Response to Comments

Sibanye-Stillwater, dba, Stillwater Mining Company, East Boulder Mine

Modification of MPDES Permit MT0026808

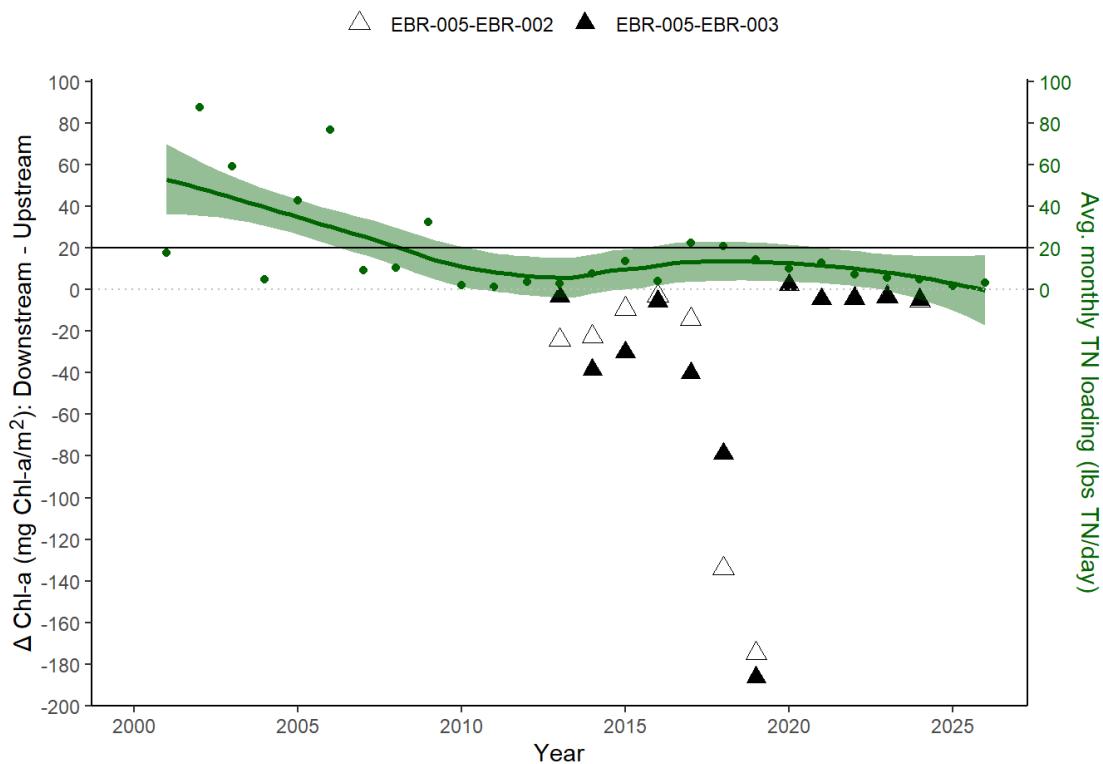
- Figure 5a. This figure should be removed as EBR-004a is in the mixing zone for TN (see Comment MMFS-17).
- Figure 5b. The measurable change threshold should be set at 19.6 mg/m² (see Comment MMFS-18).

The department agrees with the comment that, in this case, it should include an evaluation of historic discharges to historic monitoring of indicator parameters in Appendix B and has plotted the O/E metric (upon which the department's findings are largely based) alongside the combined TN load for Outfalls 002 and 003 for the 2000-2025 time period (Appendix B; Figure 10). In the same graph is shown the delta values for the O/E metric (EBR-002 minus EBR-005 and EBR-003 minus EBR-005). There were only total inorganic nitrogen (TIN) data available in the DMRs for the 2000-2014 time period, therefore the department back-calculated TN for that time period using the average discharge TN:TIN ratio for the 2015-2021 period (6.0). It takes approximately 1 year for discharges to percolate into the groundwater and work their way to site EBR-005, and the figure's loading values reflect this time lag. This change was also made to Figures 5, 8, and 10a for consistency.

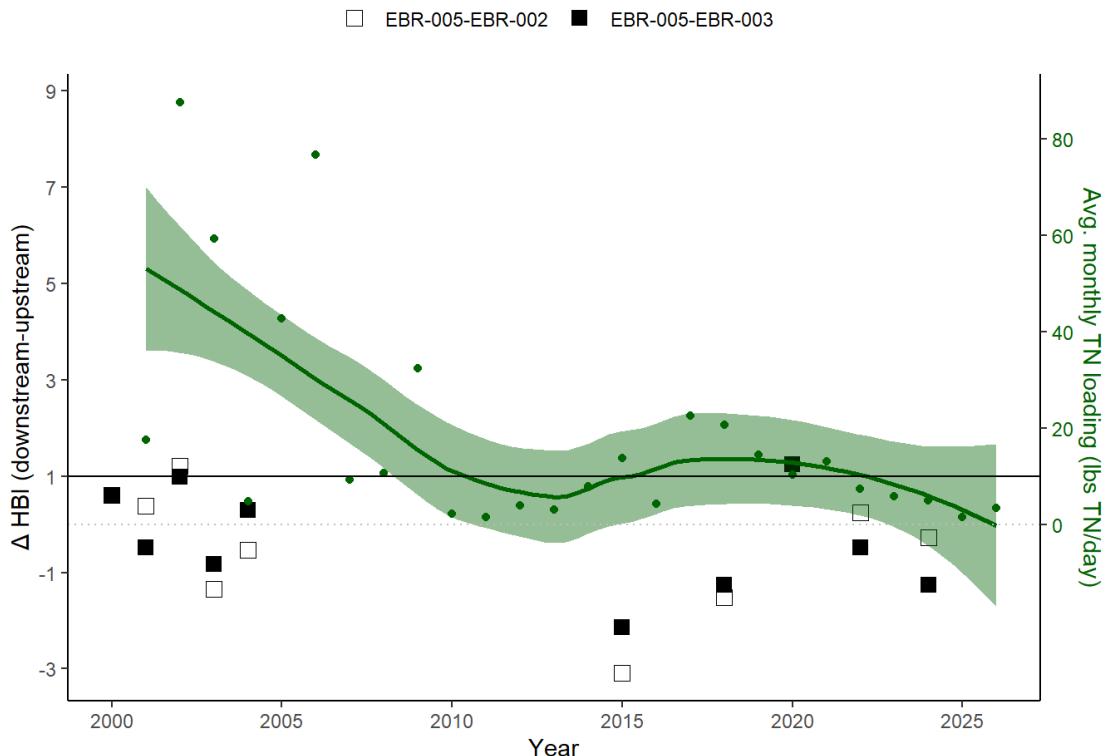
- Figure 8b. Measurable change threshold should be set at 1.9 HBI units (see Comment MMFS-20).
- Figures 9, 10a, and 10b. These figures should be removed as O/E is not a valid metric to assess nutrient impairment (see Comment MMFS-19).

Figure 2. Ambient total nitrogen (a) and total phosphorus (b) concentrations at monitoring stations EBR-001, EBR-002, EBR-003, and EBR-005 during the 2015-2018 nutrient growing seasons (July 1- Sept 30, annually). Shading indicates ecoregional range values for the Middle Rockies ecoregion.

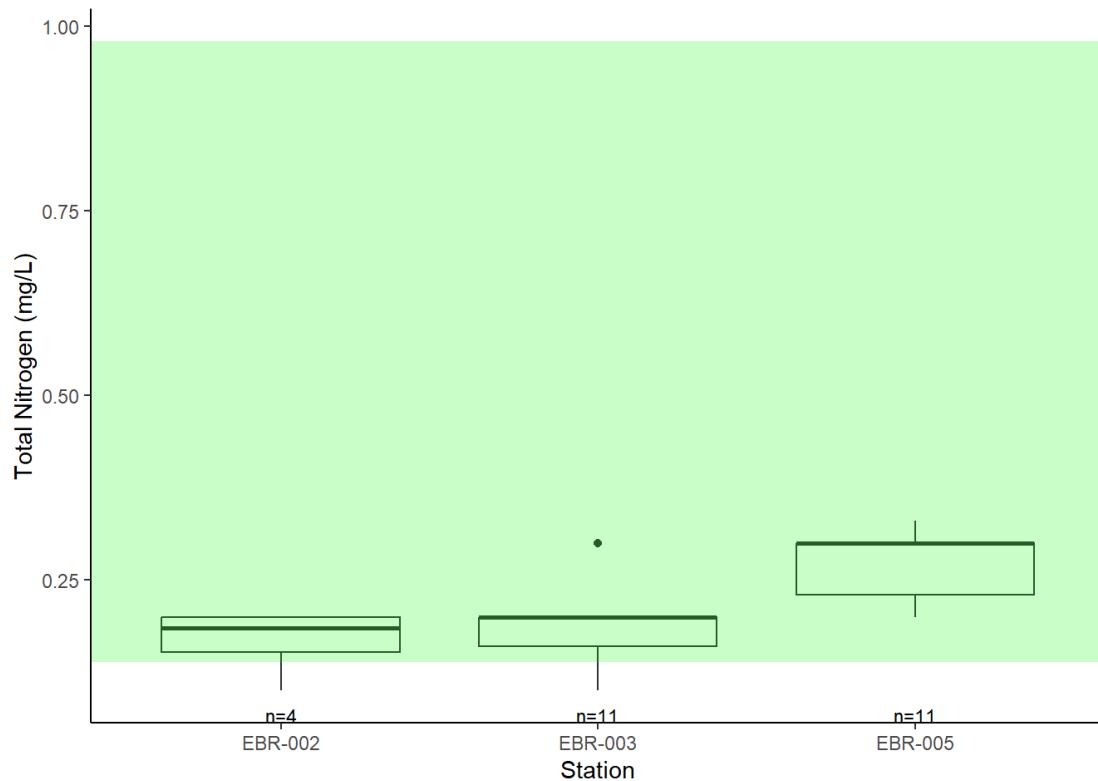
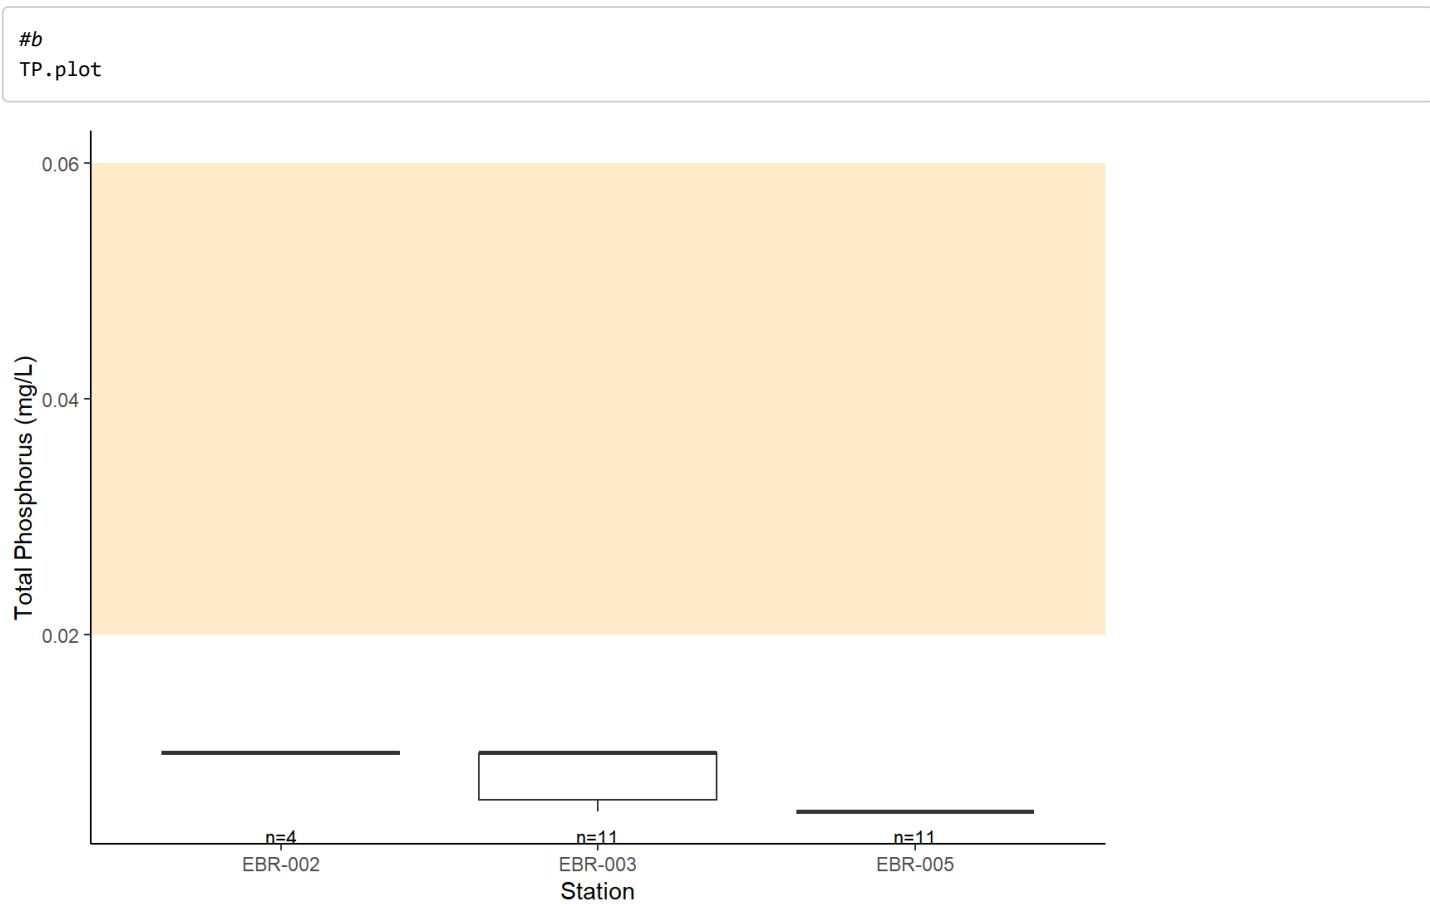
Lastly, Figure 2 of the 2025 Fact Sheet provides TN concentrations for sites EBR-001, EBR-002, EBR-003, EBR-004a, and EBR-005 during the 2015-2018 growing seasons (July 1 – Sept. 30, annually). This graph does not provide an accurate assessment to compare water quality between sites as some sites are monitored more frequently than others and therefore the box and whisker plots provided in Figure 2 of the 2025 Fact Sheet do not provide a valid basis to compare water quality between monitoring sites. SMC developed box plots that compare synoptic (collected during the same monitoring period, typically the same day) TN concentrations from EBR-001, EBR-002, and EBR-003 (see Figure 1, attached). TN plots include calculated TN (TKN + NO₂+NO₃) and TN using the persulfate analytical method. Figure 1 shows that both calculated TN and TN using the persulfate analytical method are similar to TN concentrations at EBR-001 and EBR-002.
